Information technology - SCSI Enclosure Services - 2 (SES-2)

This is an internal working document of T10, a Technical Committee of Accredited Standards Committee INCITS (International Committee for Information Technology Standards). As such this is not a completed standard and has not been approved. The contents may be modified by the T10 Technical Committee. The contents are actively being modified by T10. This document is made available for review and comment only.

Summary of Comments on SCSI Enclosure Services - 2 (SES-2)

Figure 2 — Standalone enclosure services process

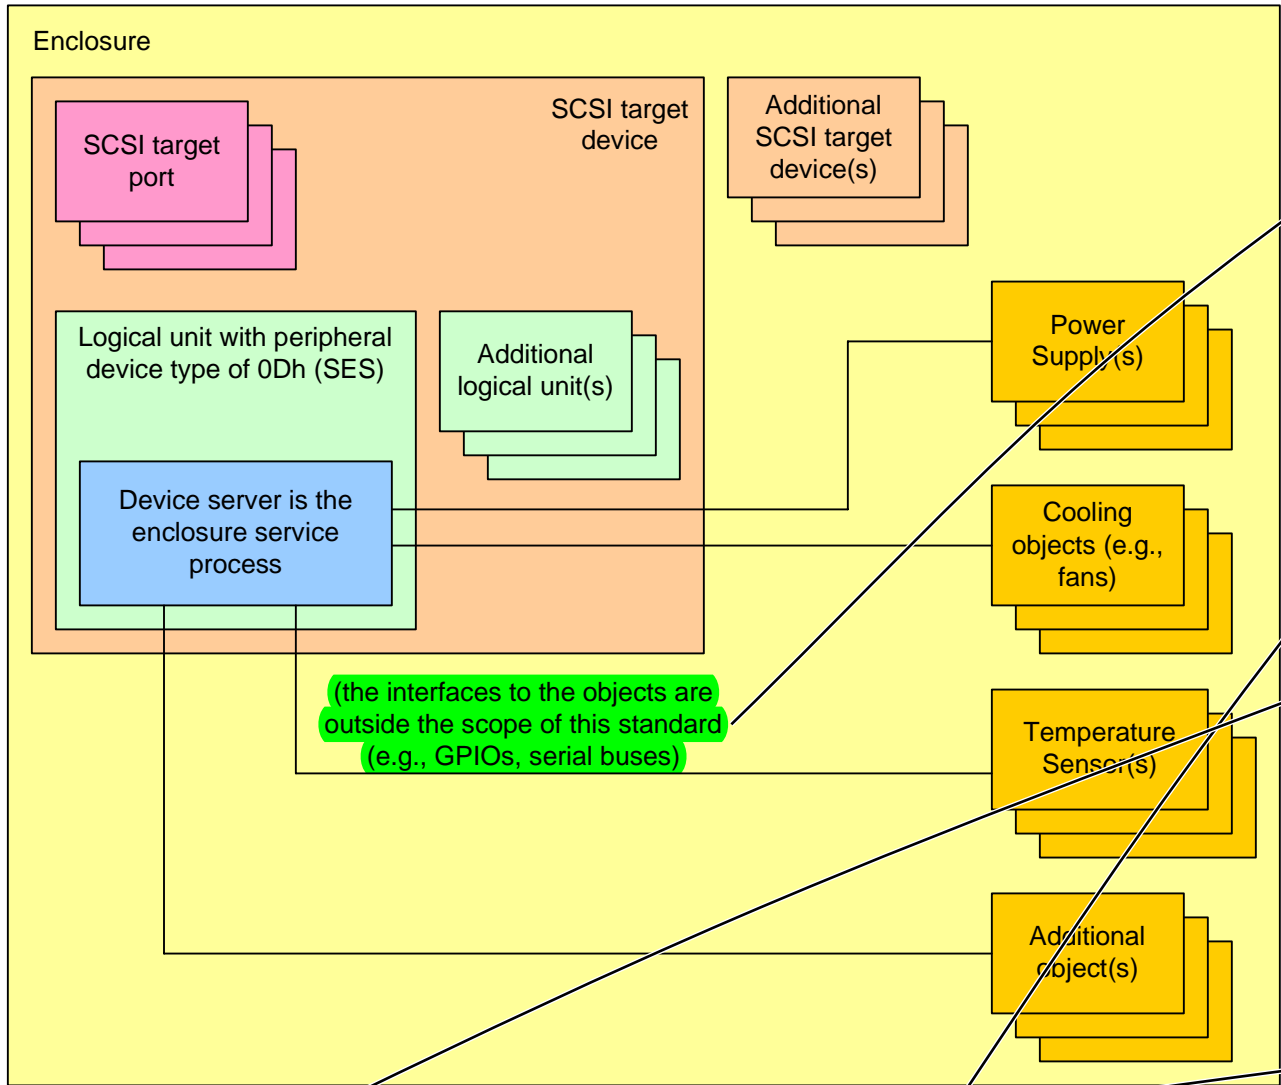
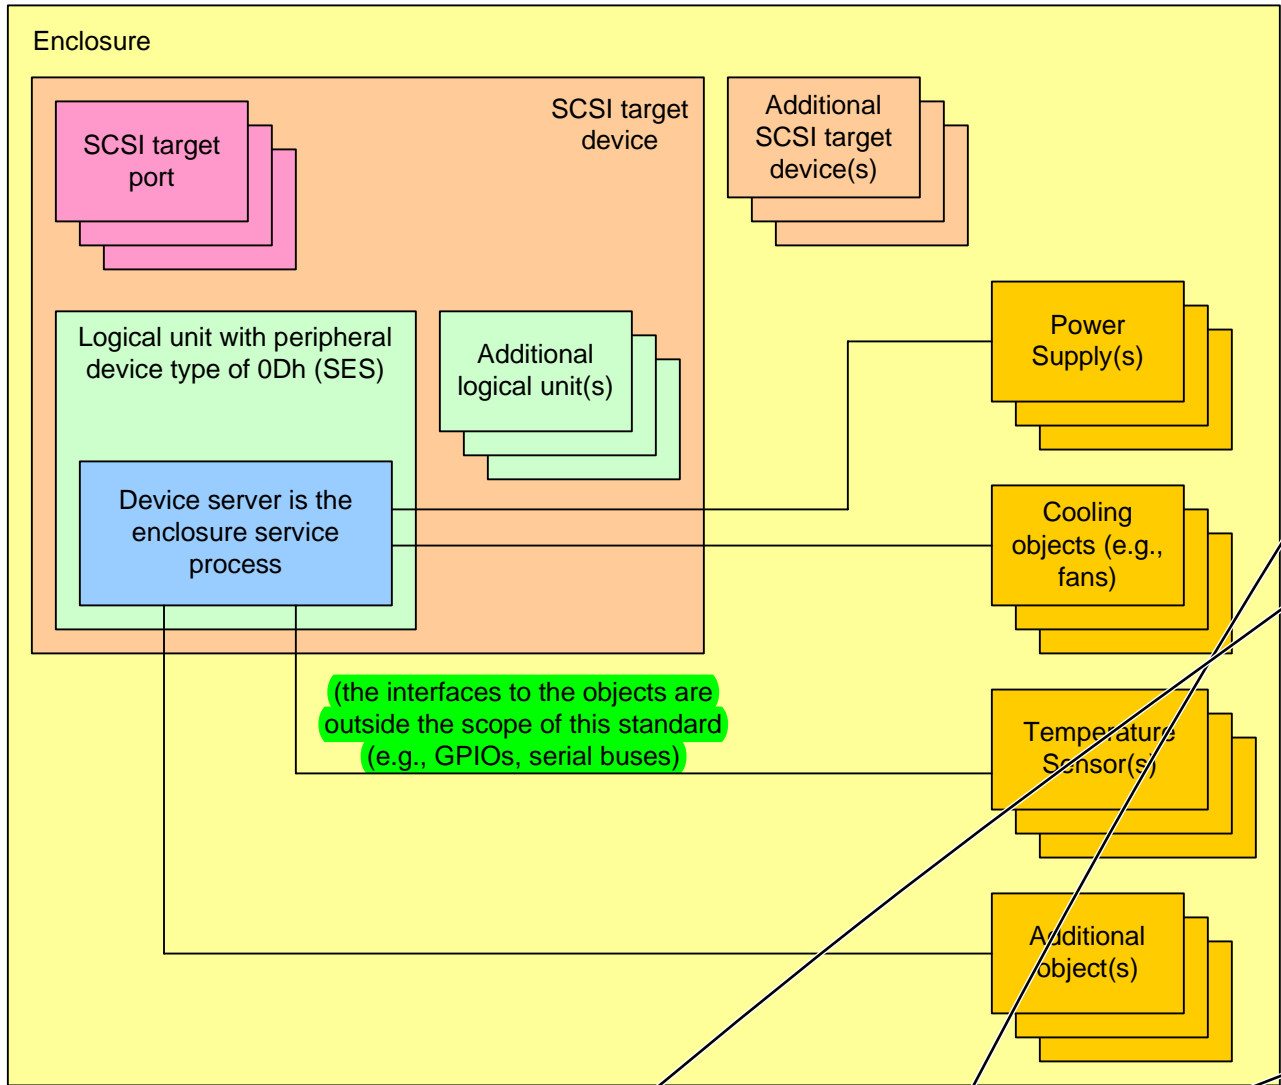
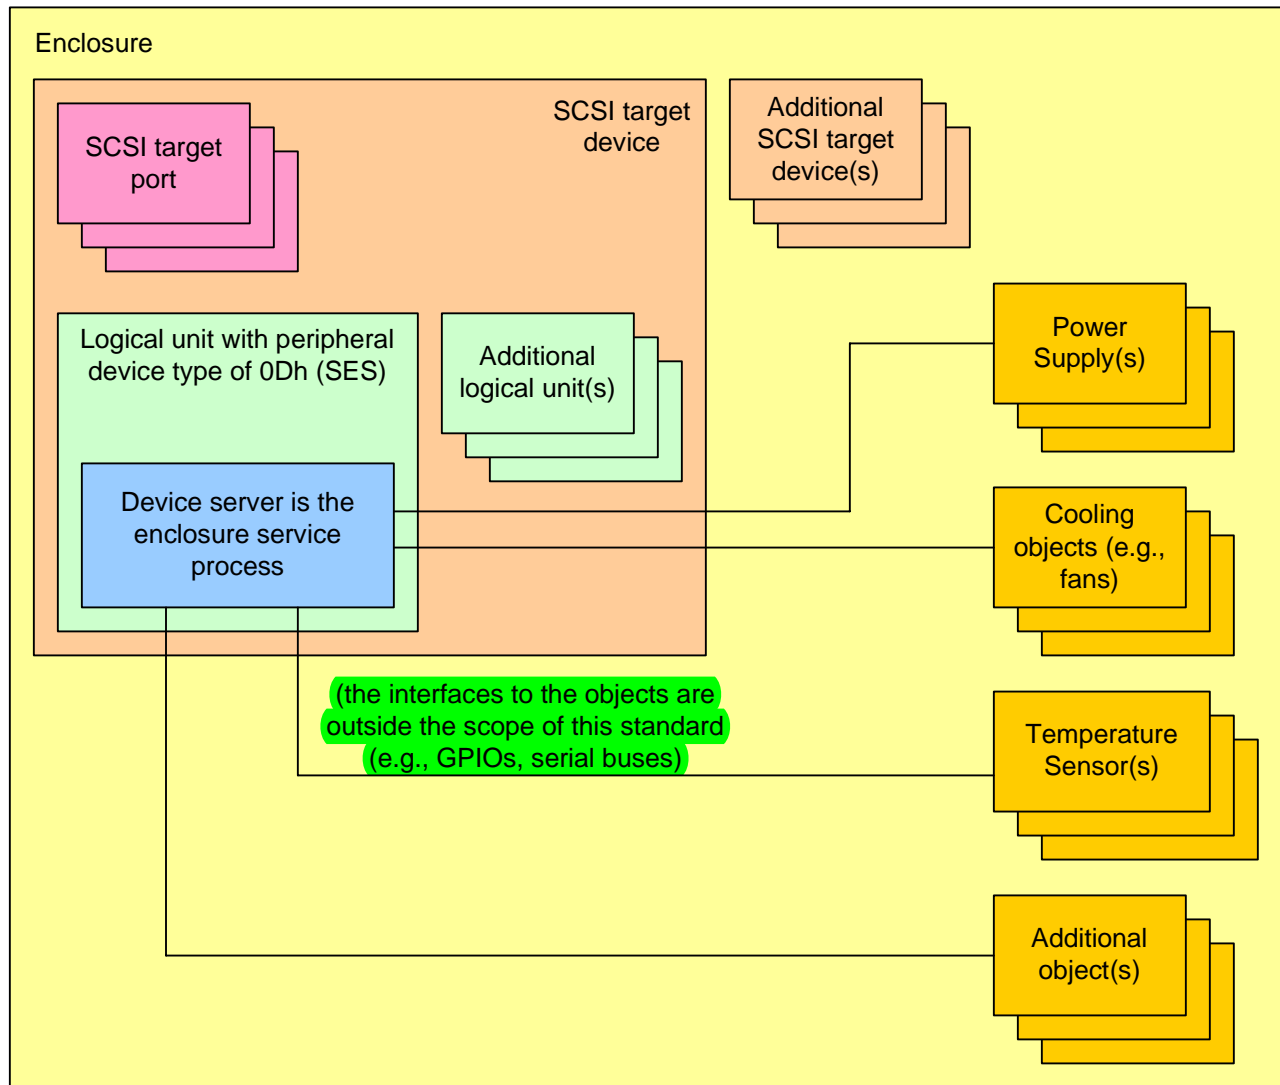
The easiest solution might be to remove "enclosure" from Figures 2 and 3 and to make everything in Table 7 and 6.1.2.2 reference subenclosures.

Author: relliott
Subject: Note
Date: 1/3/2008 6:25:36 PM
 Secondary subenclosure term defined. Subenclosure figure improved in the model. Figure added to model showing multiple enclosure services processes in a subenclosure. Those changes should address these issues.

Figure 3 — Attached enclosure services process

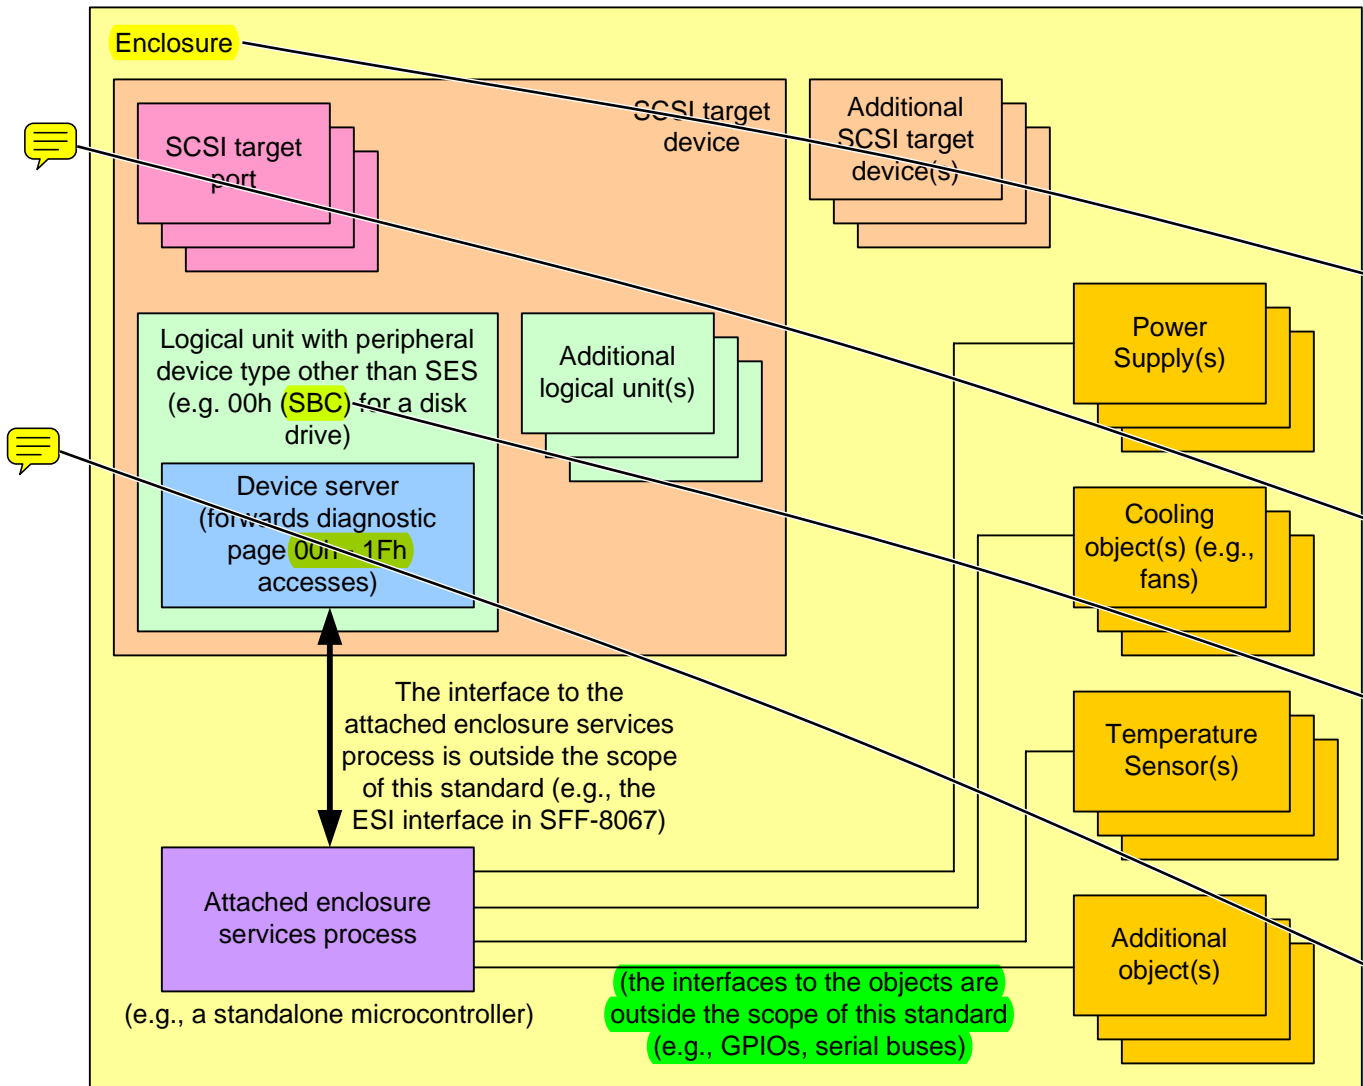
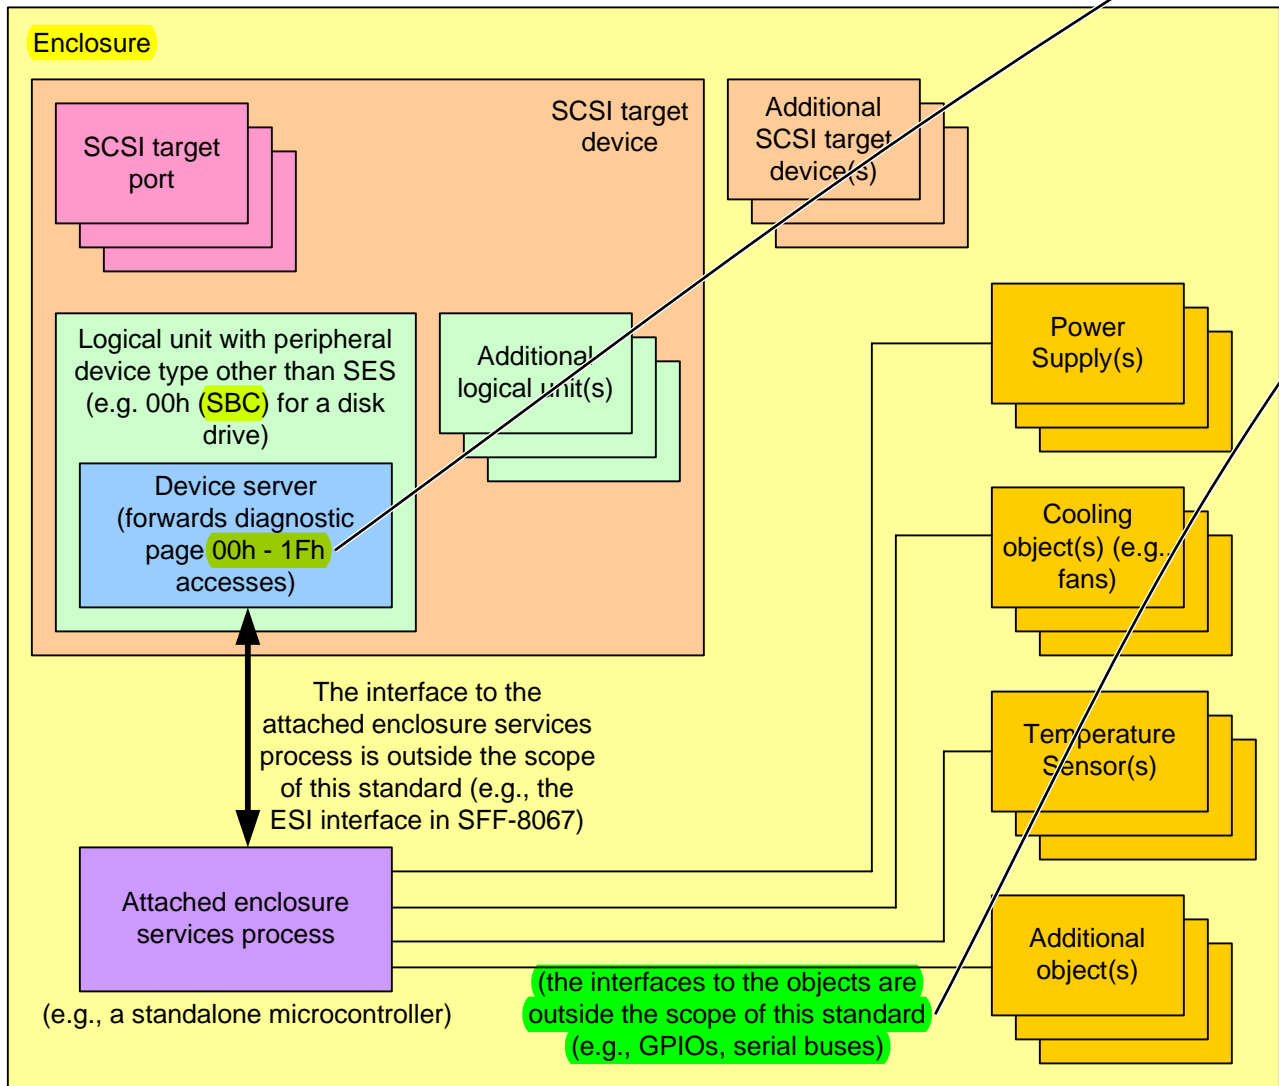
● Author: relliott
Subject: Note
Date: 1/2/2008 6:32:55 PM
 Show the enclosure boundary not wholly containing the SCSI target device

● Author: symc-roger
Subject: Note
Date: 12/13/2007 7:25:13 PM
 SYMANTEC 11
PDF pg 28, pg 10, Figure 3

Figure 4 — Subenclosures

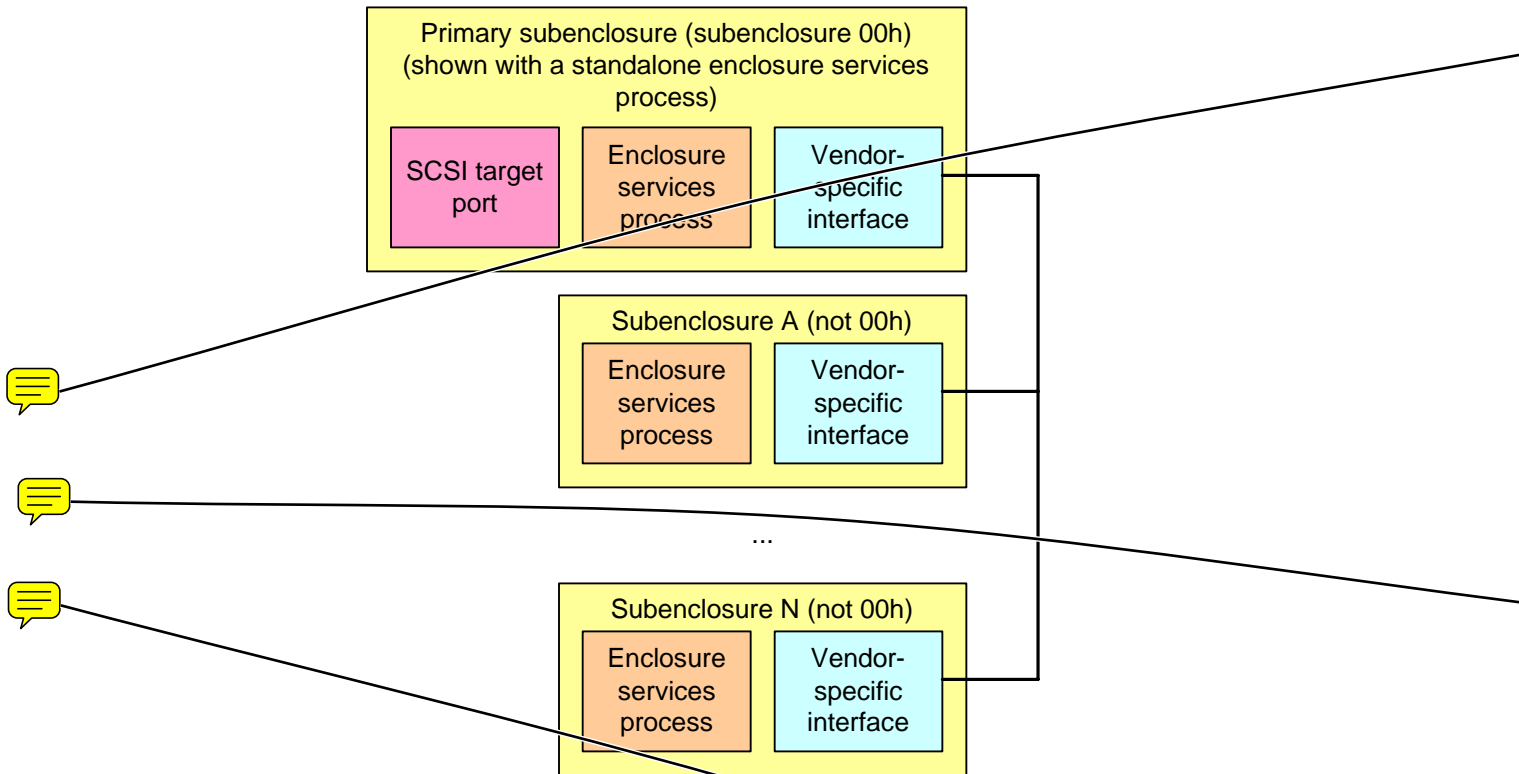
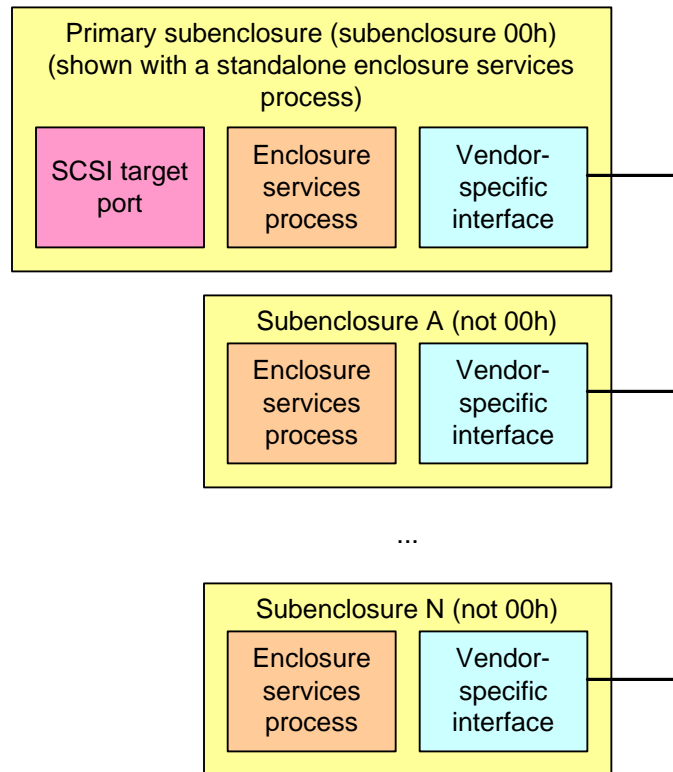
● Author: symc-roger
Subject: Note
Date: 12/13/2007 7:25:13 PM
 SYMANTEC 18
PDF pg 31, pg 13, Figure 4

The enclosure descriptor of the configuration diagnostic page supports multiple enclosure service processes per subenclosure, and this should be reflected in the figure.

● Author: symc-roger
Subject: Note
Date: 12/13/2007 7:25:13 PM
 SYMANTEC 19
PDF pg 31, pg 13, Figure 4

The figure is the only place that indicates that the subenclosure identifier of the primary subenclosure should be 00h.

Also, added a Enclosure box to the figure surrounding all the subenclosures.

Author: relliott
Subject: Note
Date: 1/2/2008 6:35:22 PM
 added new section and new figure showing that. It's too complicated to overlay that with multiple subenclosures (which would then demand that standalone/attached be included as well).

Prepend the following sentence to the second paragraph after the figure: "The subenclosure identifier of the primary subenclosure shall be 00h."
